# Staff Report

**Item:** DR 2019-11 & PLA 2019-05 "GEM Equipment" at 2765 National Way

Action on a consolidated land use application package, Design Review DR 2019-11 for an industrial manufacturing facility in the Industrial Park (IP) zone, with Property Line Adjustment PLA 2019-05.

26 SITE PLAN  
A1.0

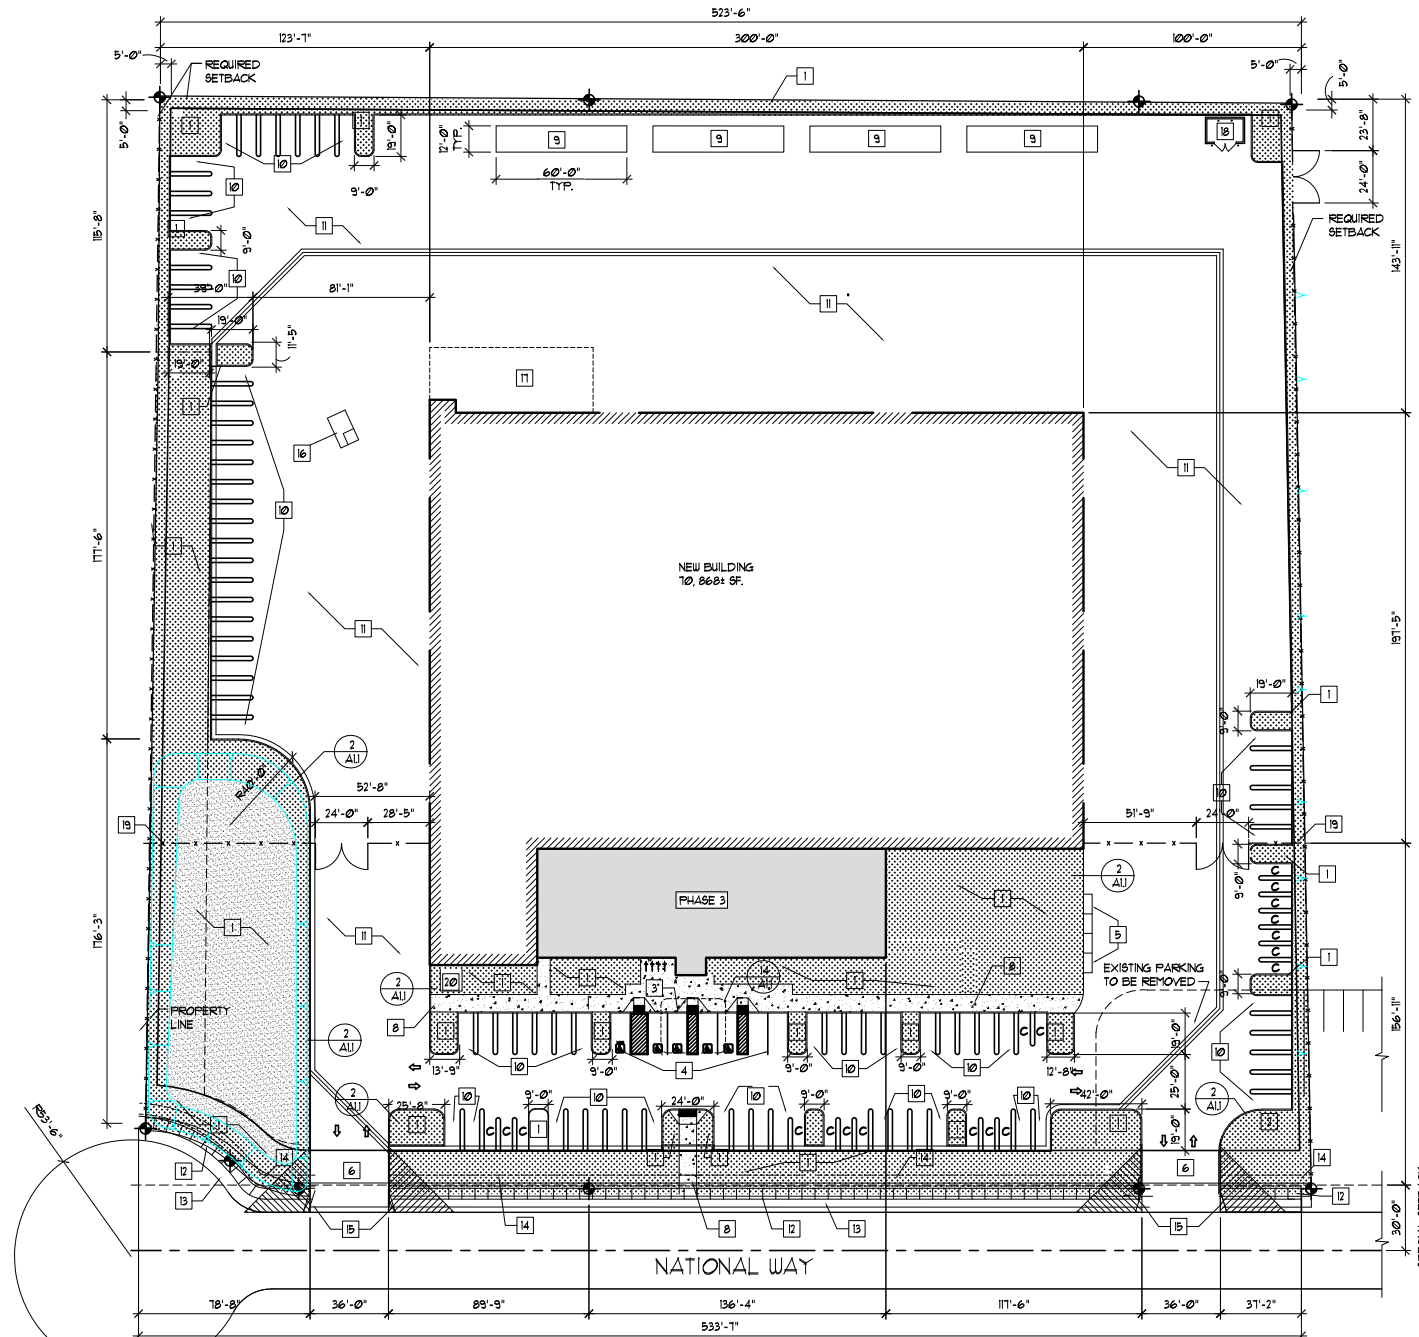
At 1 space per 10 required parking stalls, the resulting bicycle parking requirement is 9 spaces. The site plan (Attachment 104; Exhibit A) notes via Key Note 7 a covered bicycle rack however it is not indicated in the drawing. Additionally, the narrative and site plans do not indicate the total number of bicycle parking spaces provided; Detail 25 (Attachment 104; Exhibit D) indicates a “wave” style bicycle rack with 7 spaces. Staff applies *Condition of Approval D2b* to indicate on a site plan the location(s) of bicycle rack(s) within 50 ft of the main entrance and show conformance with minimum bicycle parking spaces.

The applicant proposes all stalls at the 90° angle. The site plan (Attachment 104; Exhibit A) indicates all stall dimensions meeting minimum standards, except compact stall dimensions are not provided. Staff applies *Condition of Approval D2c* to update plans to show dimensions meeting the requirements of Table 3.05C and, if applicable via 3.05.02H., wheel stops.

The site plan (Attachment 101; Exhibit A) and landscape plan (Attachment 101; Exhibit E) indicate and note a 3 ft berm providing visual screening for the parking area abutting the street. This does not meet the minimum 42-inch height requirement of the provision therefore staff applies *Condition of Approval D4* to obtain conformance.

D4. Screening: To meet WDO 3.06.05B., the applicant shall modify the plans to indicate a berm, or other form of visual screening identified by the provision, at 42 inches (3.5 ft) in height.

18 EAST ELEVATION  
A6.1 PEMB

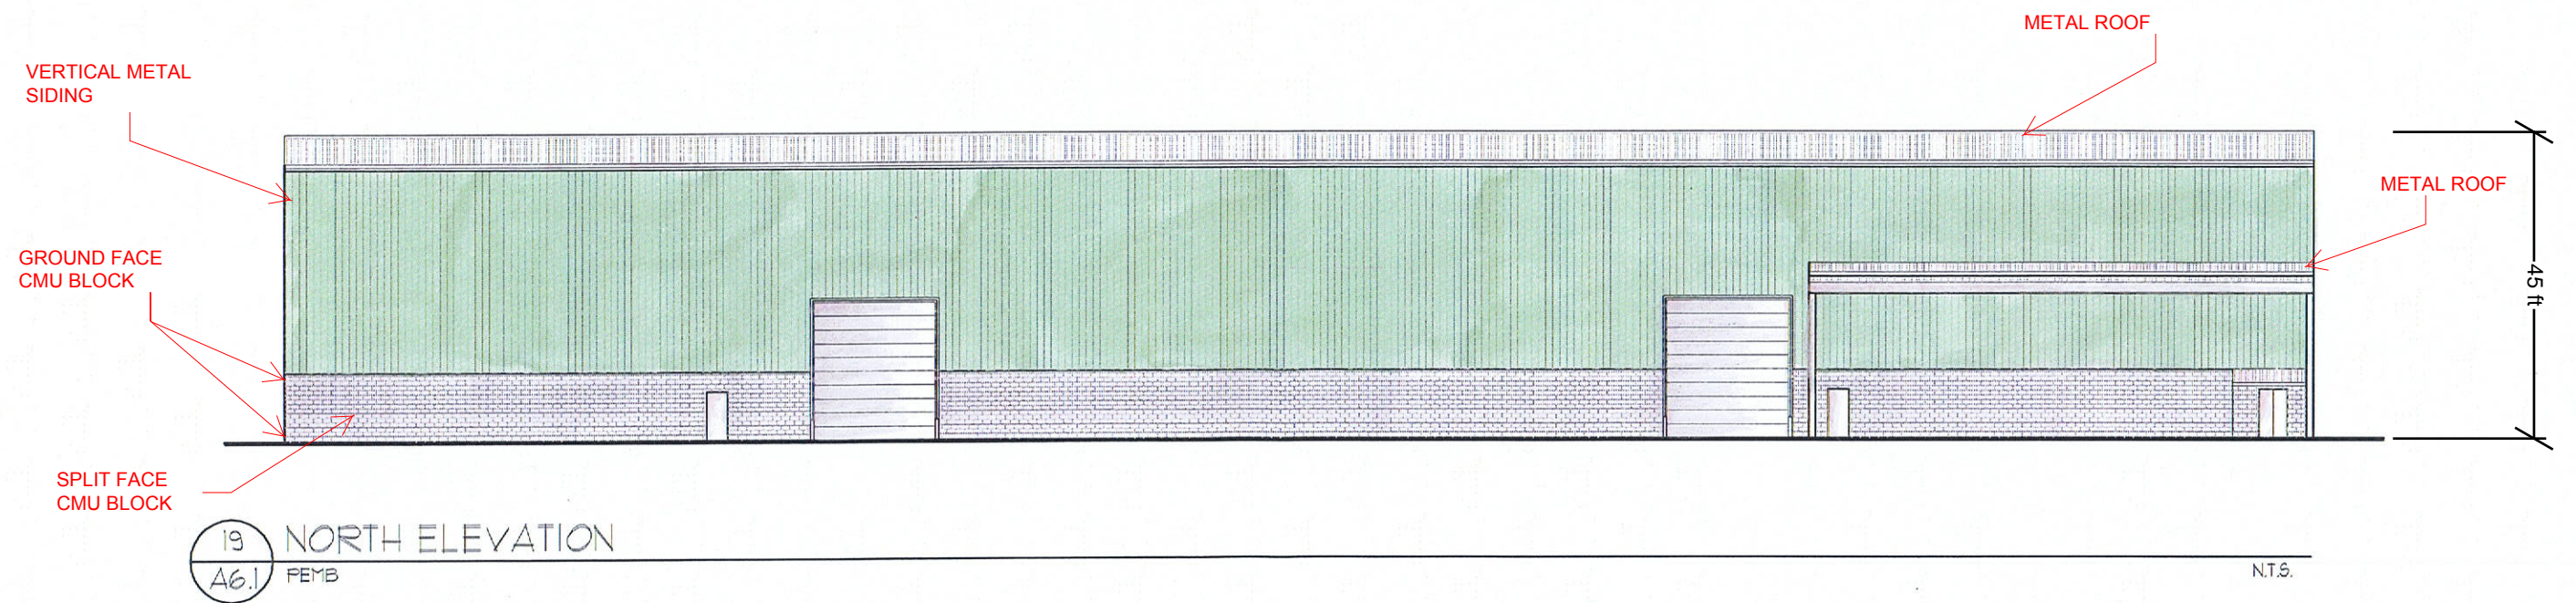
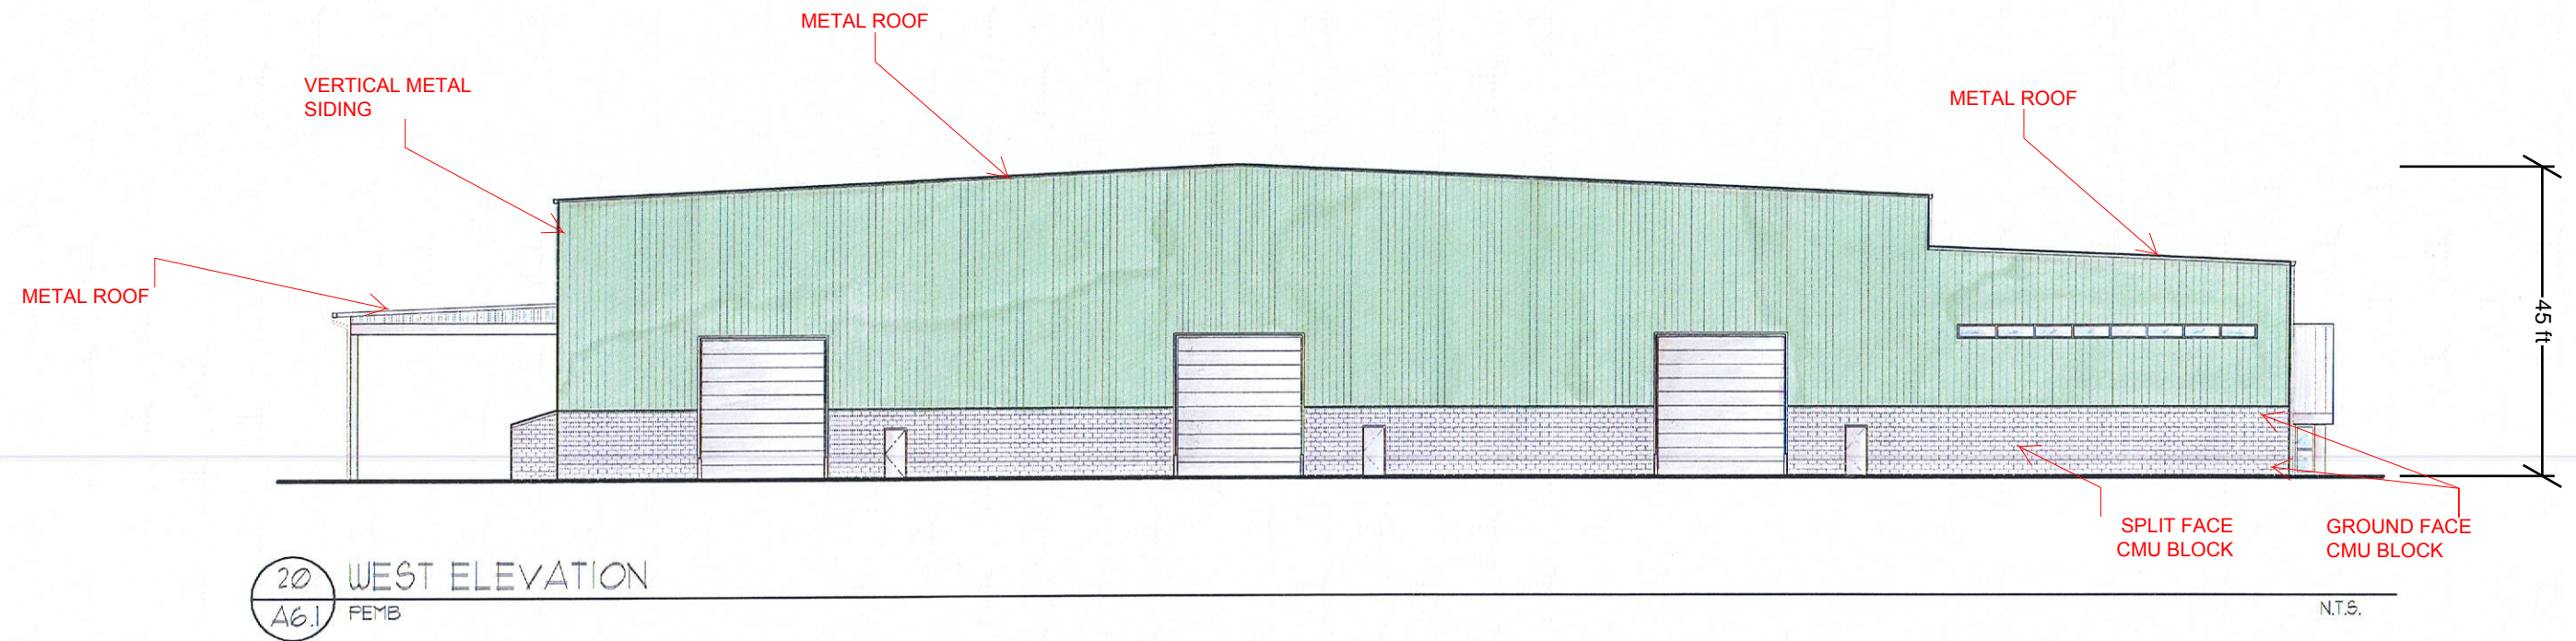
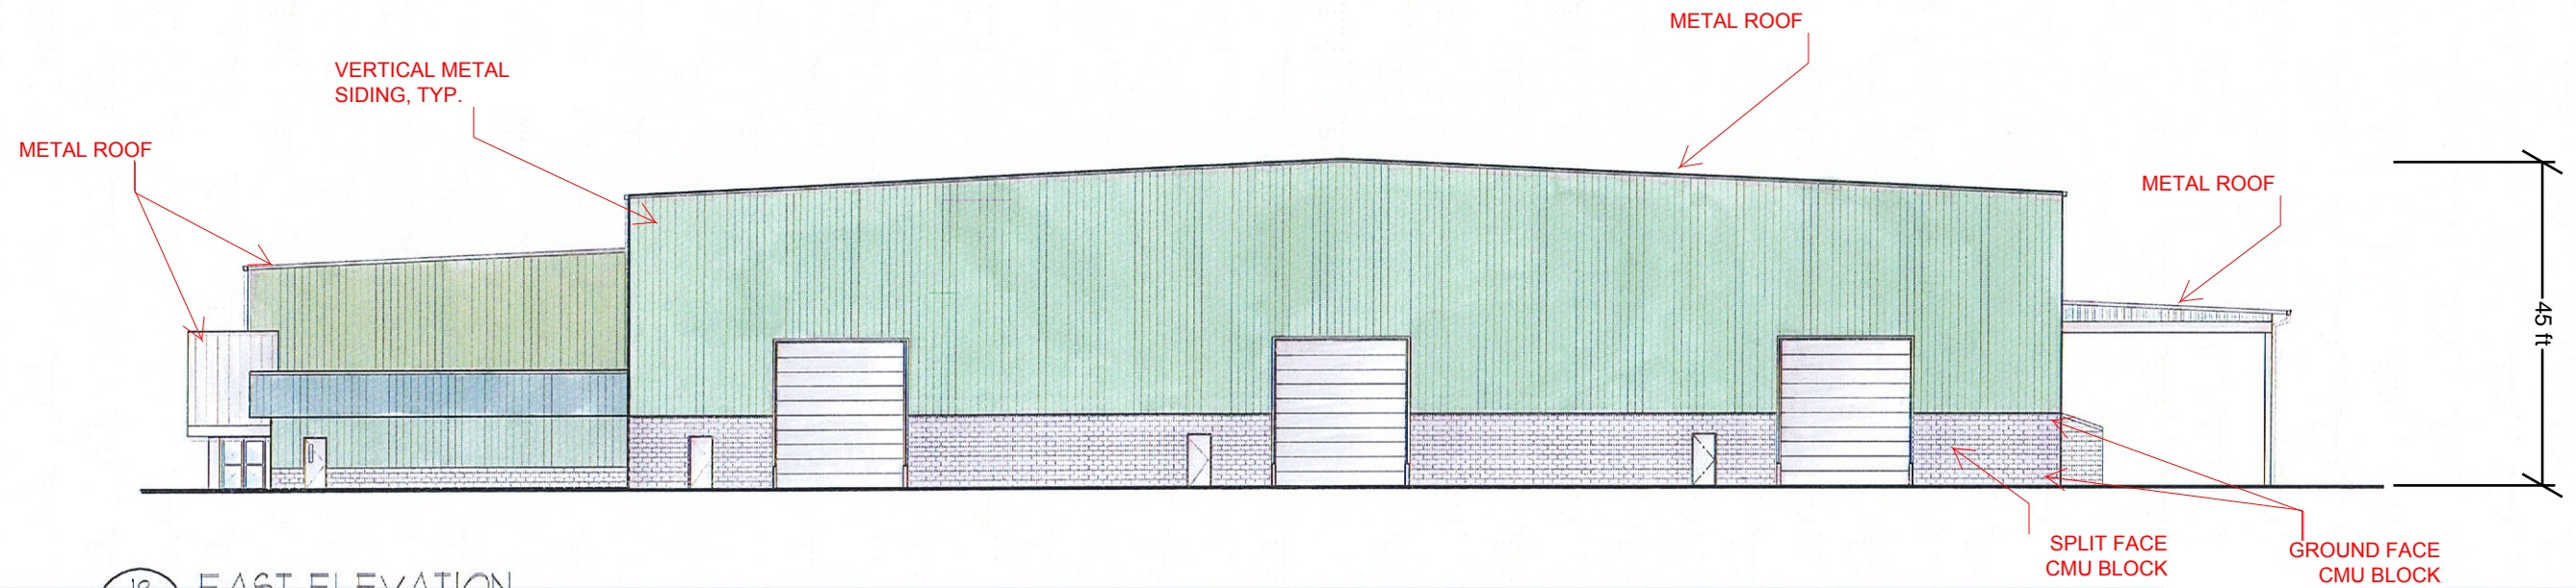
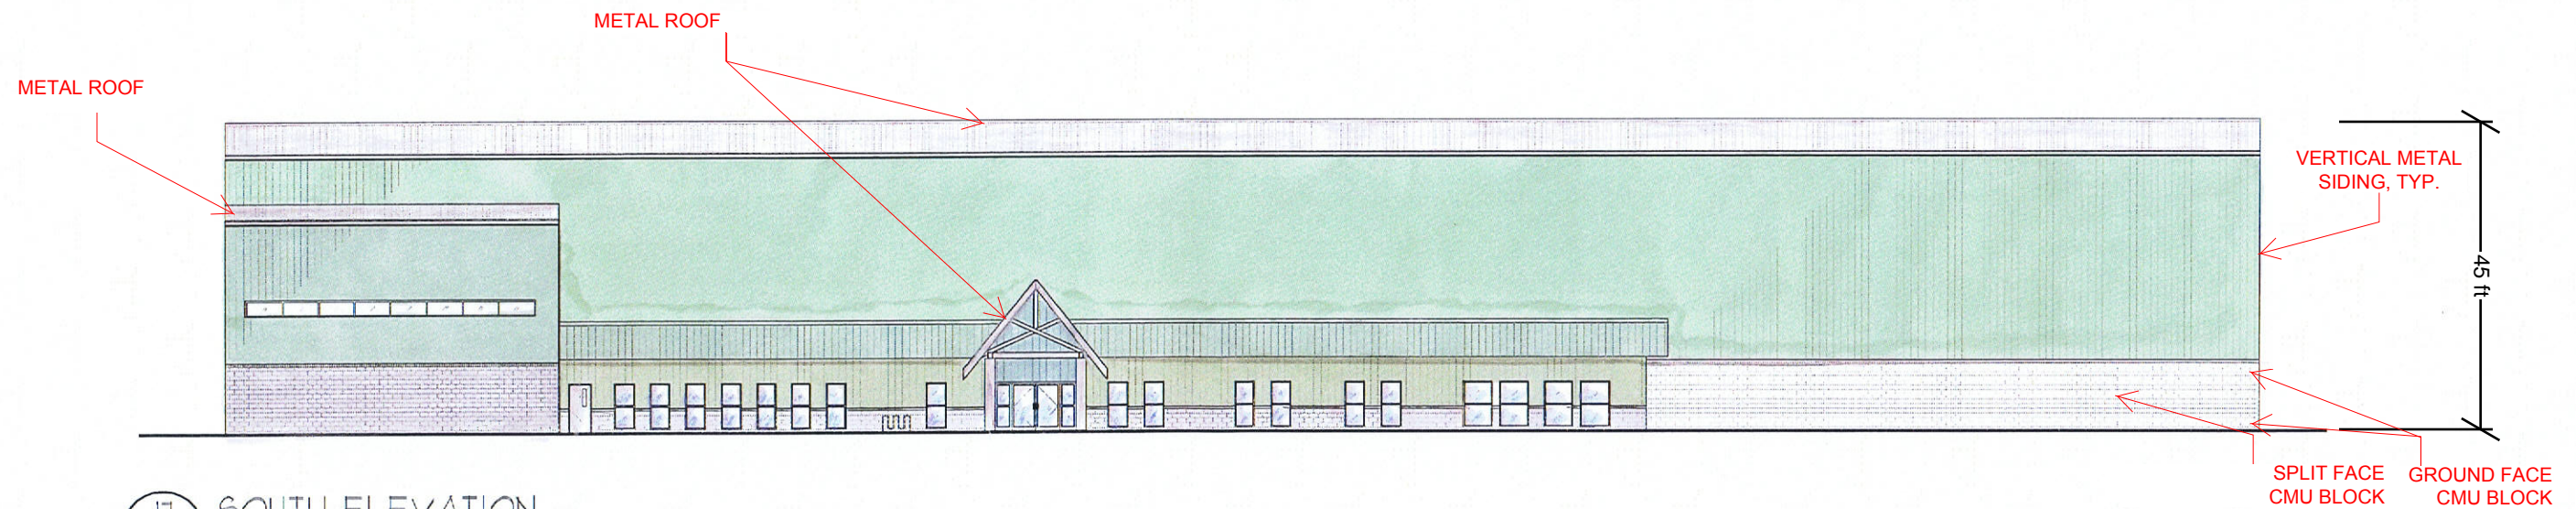
The building elevations appear to be mislabeled. The 'East' elevation appears to be North, the 'South' appears to be East, the 'West' appears to be South, and the 'North' appears to be West. Staff adds *Condition of Approval D6* to correct these labeling errors. With that said, the front elevation indicates an articulated front façade meeting item a. with differing roof heights for the office area versus the manufacturing area.

D6. Elevations: To correct mislabeled building elevations, the applicant shall update the elevation sheets to show correct elevation labels for the north, south, east, and west elevations.

17 LANDSCAPE PLAN  
 1" = 40'-0"

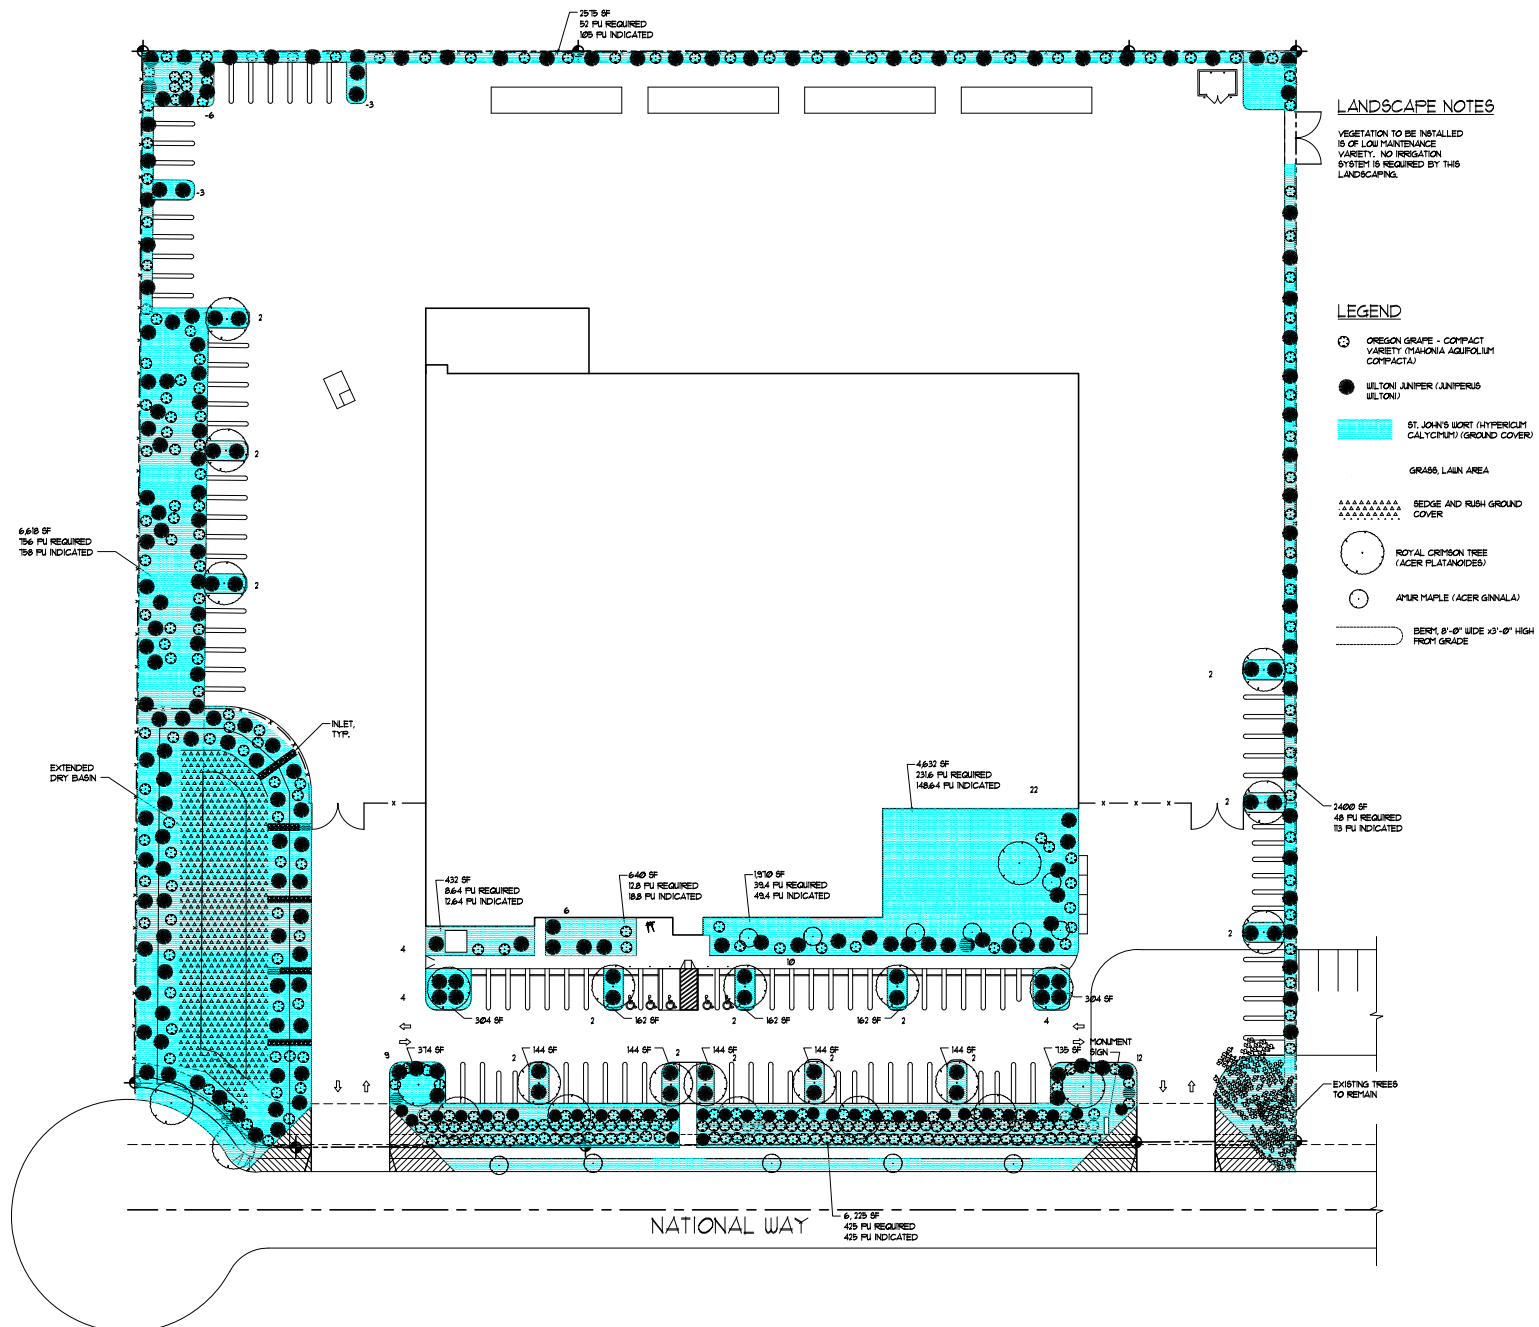
The lot has 461.34 ft of frontage, which per the 1 tree per 50 ft of frontage requirement equals 9 required street trees. The landscape plan (Attachment 101; Exhibit E) indicates a total of 7 street trees, 2 less than the minimum. Additionally, 2 of the 7 street trees are identified as the tree species *Acer platanoides*, which is a tree species found in the Table 3.06C 'Prohibited Trees'.

An excerpt of Sheet L1.1 showing the two prohibited street trees.

Staff adds *Condition of Approval D3* to show conformance with street tree requirements, including number, size, and species.
